**PARK 410 WEST
PRELIMINARY OVERALL AREA DEVELOPMENT PLAN**

PARK 410 WEST
PRELIMINARY OVERALL AREA
DEVELOPMENT PLAN
427.388 ACRE TRACT

Re: Park 410 West POADP
File: 84-11-58-04
Revised: 10/10/85

Re: Park 410 West ☐ Preliminary Plan
☒ P.O.A.D.P.
File #: 84-11-58-04

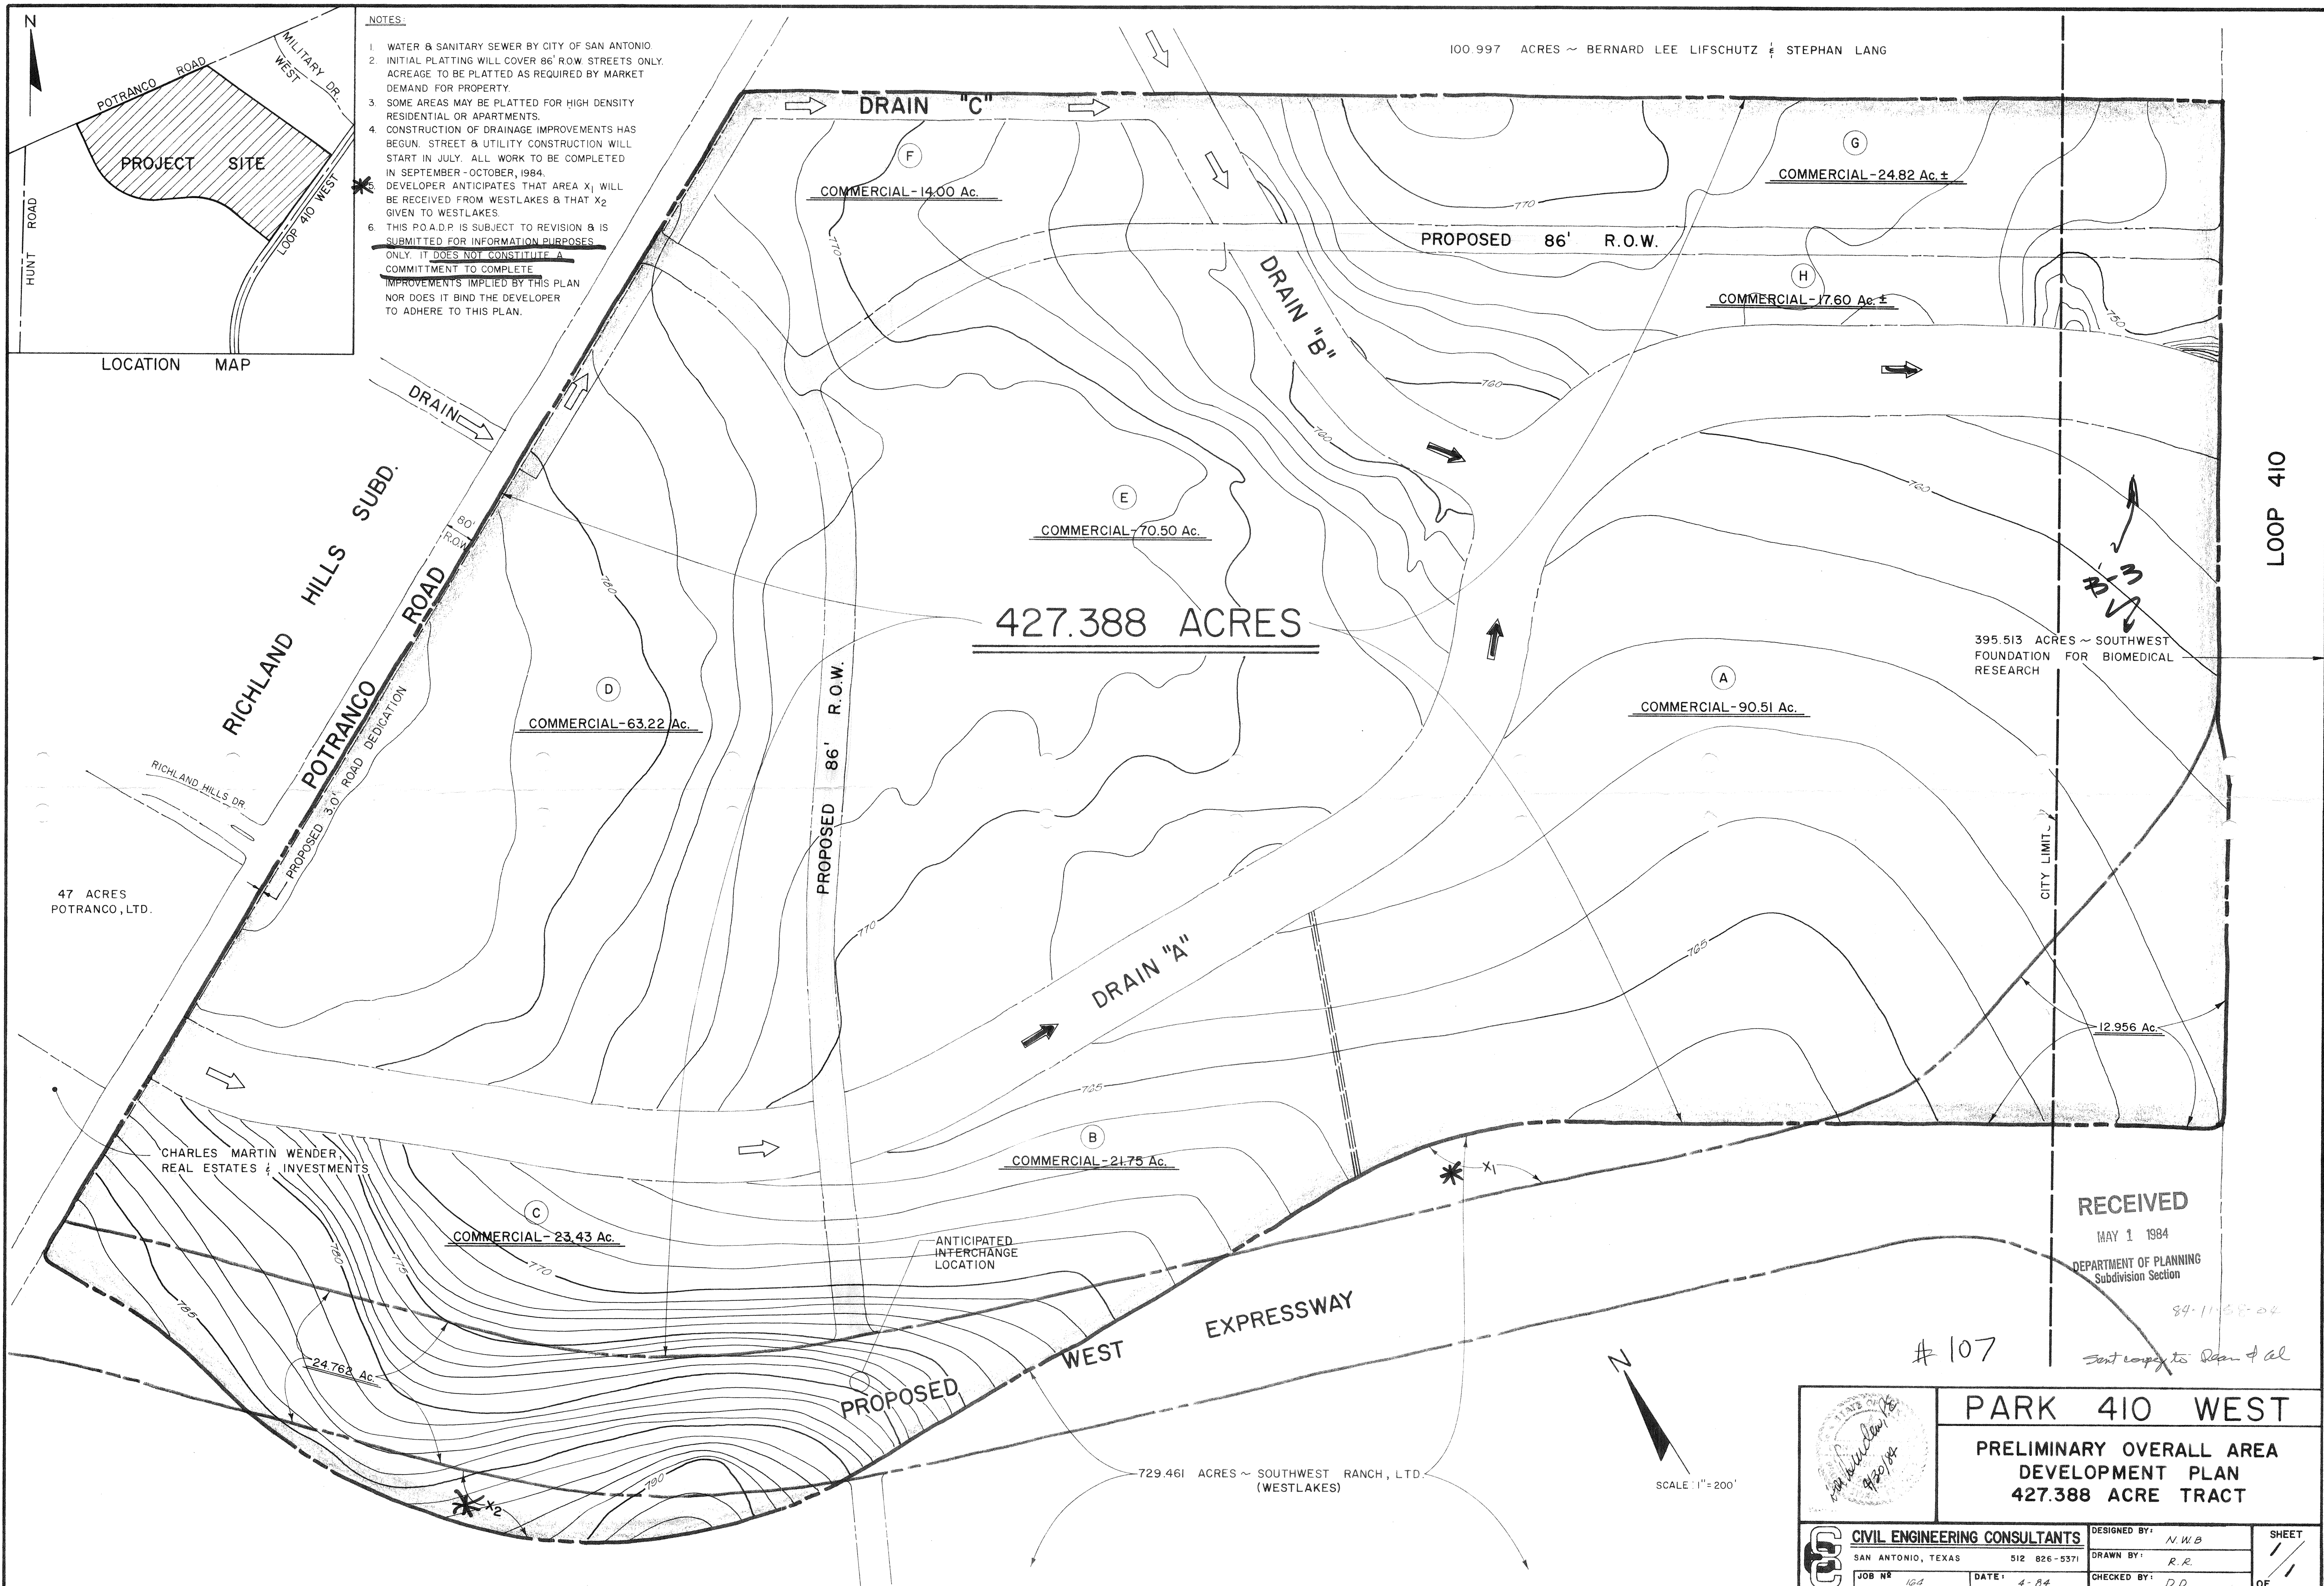
(X) Comments: Staff concurs with the planned design. However, it is recommended that any potential change in location of the north-south 86' facility be coordinated with the property owner to the south. (Southwest Ranch L.T.D.)

PARK 410 WEST
PRELIMINARY OVERALL AREA DEVELOPMENT PLAN

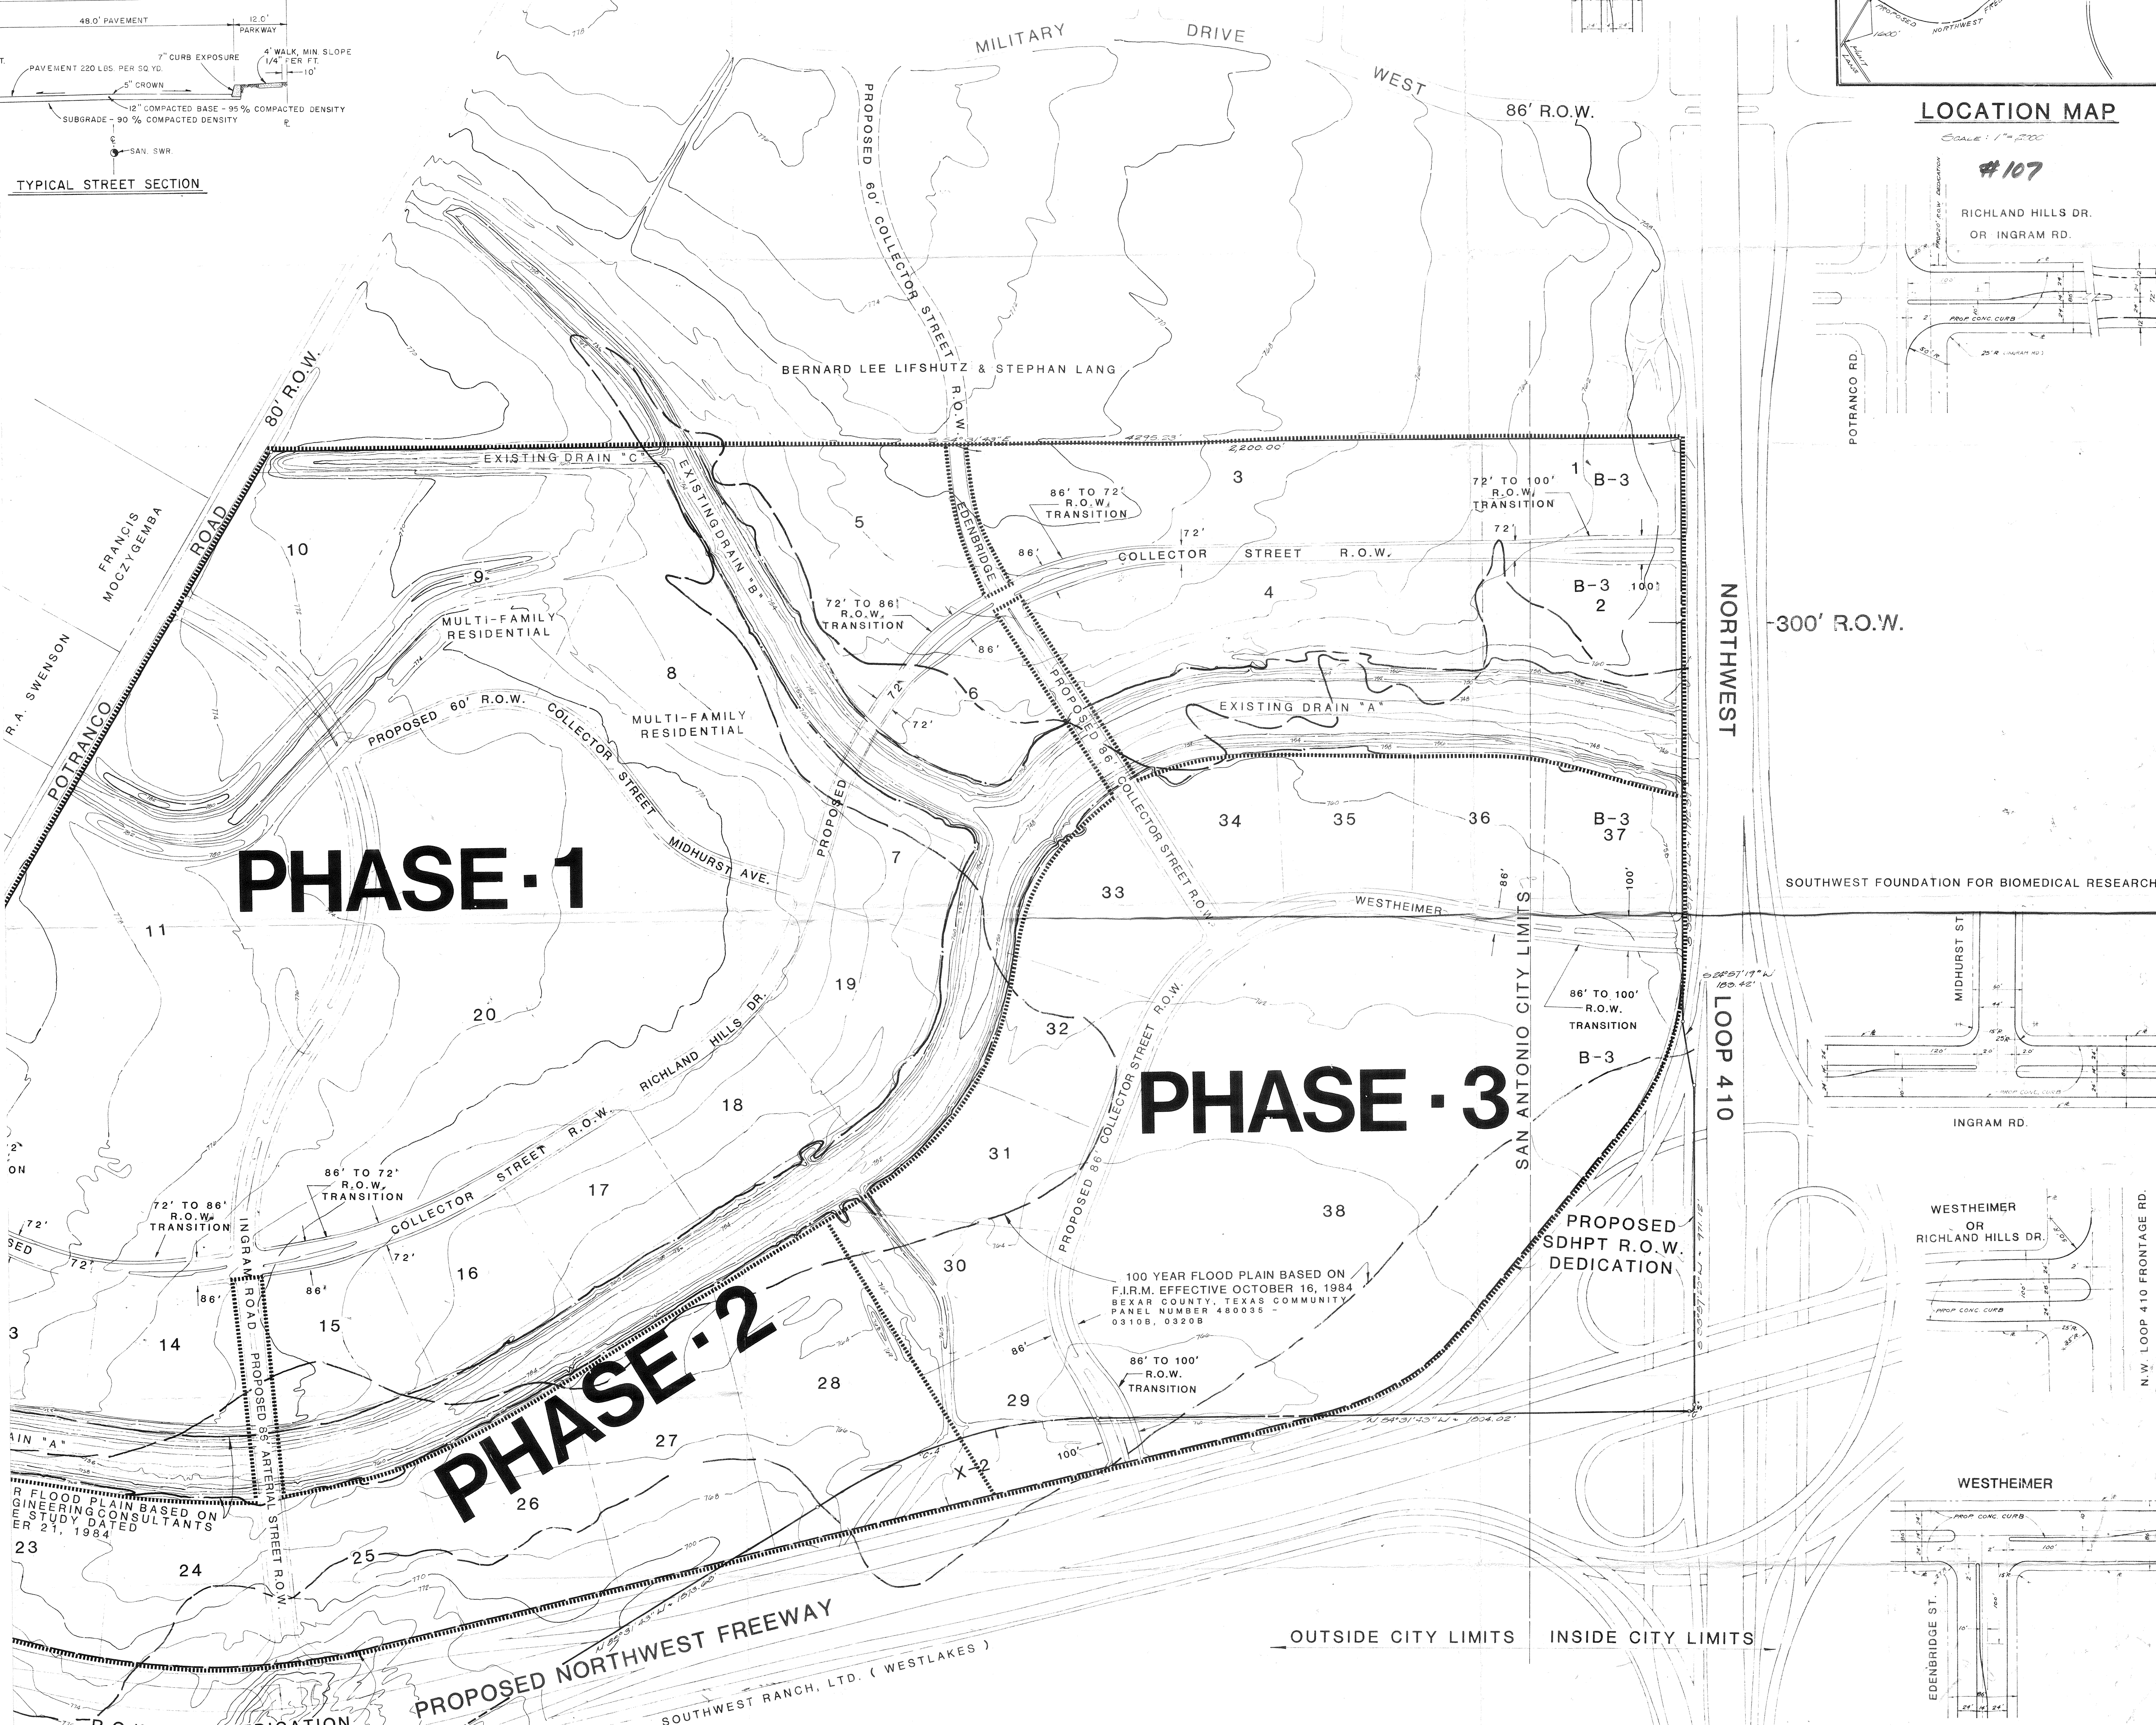
The POADP has been revised to reflect changes made to the phase layout and the proposed street right-of-way for Richland Hills Drive. It also incorporates intersection details. These intersection details are provided to show proposed left-hand turn lanes, and right-of-way transitions. Both of these revisions and additions have been made based upon recommendations by David Stietle, City of San Antonio Assistant Public Works Director, during a meeting between Mr. Stietle and me.
